# Access Compliance Report

## Public Rights-of-Way

### (Curb Ramps)

Intersection ID: 18365	Main Street: S_TRYON_ST	Cross Street: W_TYVOLA_RD	Location: SE
ADA ID: 664EF574C56E	Ramp Type: Perp	Initial Pass/Fail: Fail	Overall Compliance: No
Severity Score: 12.5			
Codes/Mitigation Info/Possible Solution		Field Measurements/Component Compliance

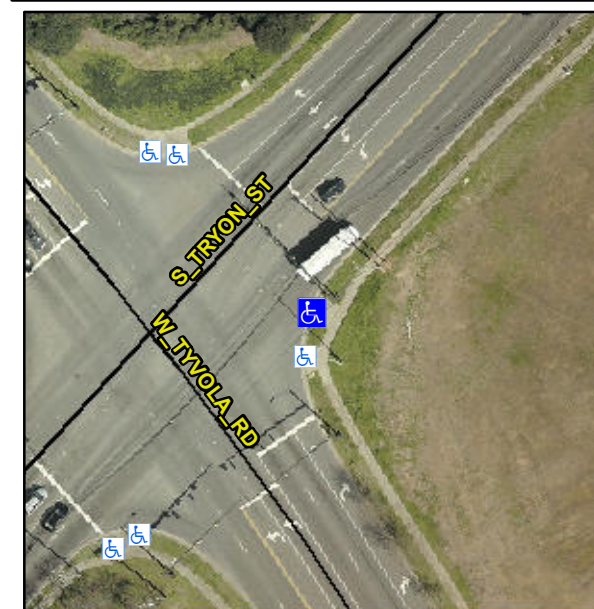
**Not Found, R304.2.2**

Compliance	Description	Data	Compliance	Description	Data
N/A	Ramp Length (in)	122.0	No	Ramp Slope (%)	8.4
Yes	Ramp Width (in)	48.0	Yes	Ramp XSlope (%)	0.5
N/A	Flare Type LT	N/A	N/A	Flare Type RT	N/A
N/A	Flare Slope LT (%)	N/A	N/A	Flare Slope RT (%)	N/A
N/A	Flare Traversable LT?	N/A	N/A	Flare Traversable RT?	N/A
N/A	Landing Length (in)	N/A	N/A	DWS Provided?	N/A
N/A	Landing Width (in)	N/A	N/A	DWS Contrast?	N/A
N/A	Landing Slope (%)	N/A	N/A	DWS Length (in)	N/A
N/A	Landing X Slope (%)	N/A	N/A	DWS Full Width?	N/A
N/A	Landing Curb? (Y/N)	N/A	N/A	DWS Offset (in)	N/A
N/A	Shared Landing?	N/A			
N/A	Gutter Ponding?	N/A	N/A	Gutter Slope (%)	N/A
N/A	Gutter Lip Ht (in)	N/A	N/A	Gutter X Slope (%)	N/A
N/A	Painted X Walk1?	No	N/A	Painted X Walk2?	N/A
	X Walk 1 Direction	To NW		X Walk 2 Direction	N/A
N/A	X Walk 1 Width (in)	N/A	N/A	X Walk 2 Width (in)	N/A
	X Walk 1 Slope (%)	1.7		X Walk 2 Slope (%)	N/A
	X Walk 1 X Slope (%)	1.8		X Walk 2 X Slope (%)	N/A

**Remove & Replace Entire Ramp.**
